### Addendum No. 1

**City of Coquitlam**  
**Tender 84495-3**  
**Austin Heights Sanitary Upgrades Phase 3**  
**Issue Date:** January 17, 2025  
 (Consists of 5 Pages)

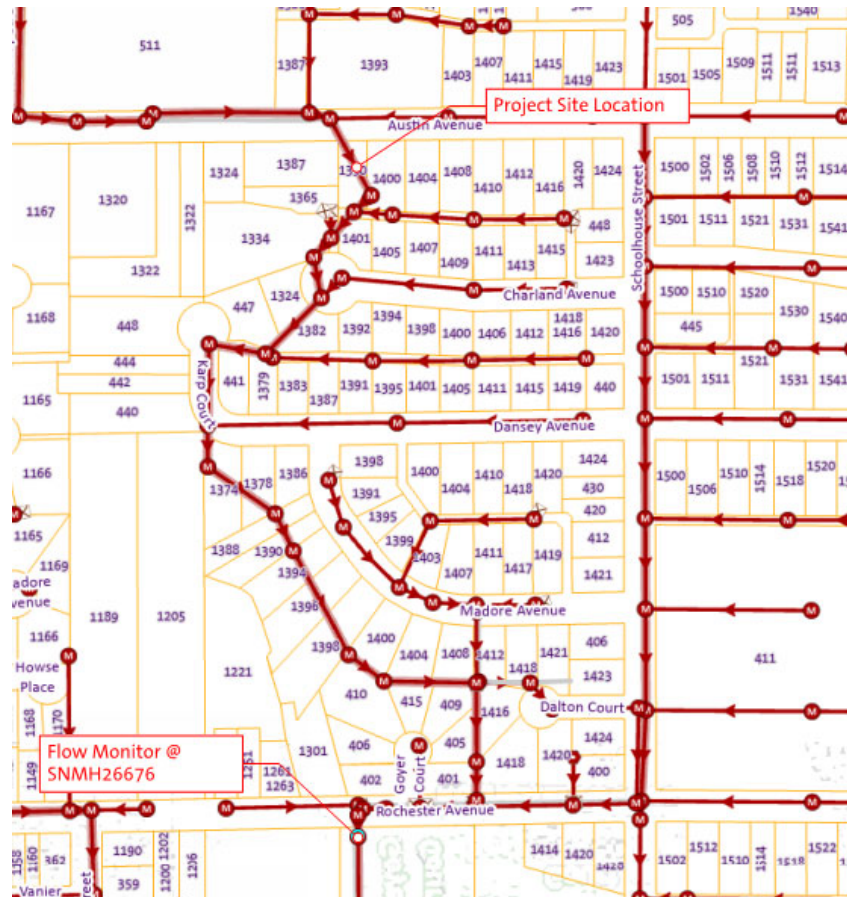
Q7: Can sewer flow rates including relevant data for the project location in order to evaluate the existing infrastructure capacity be provided?

**A7: Please refer to the table below which is based on the most recent flow monitoring data. The flow monitor is located at 1300 Rochester Avenue (location map shown below) and is downstream from the project site. Rates may be more conservative than the actual flow rates experienced upstream. The Contractor is responsible for providing sufficient bypass pumping based on site conditions.**

2024 Flow Monitoring Data – 1300 Rochester Avenue			
Jan1-April 30	Maximum	1399.149	GPM
	Average	307.4984	GPM
May 1 - Aug 31	Maximum	730.905	GPM
	Average	188.1949	GPM
Sept 1 - Dec 31	Maximum	4118.218	GPM
	Average	337.3669	GPM
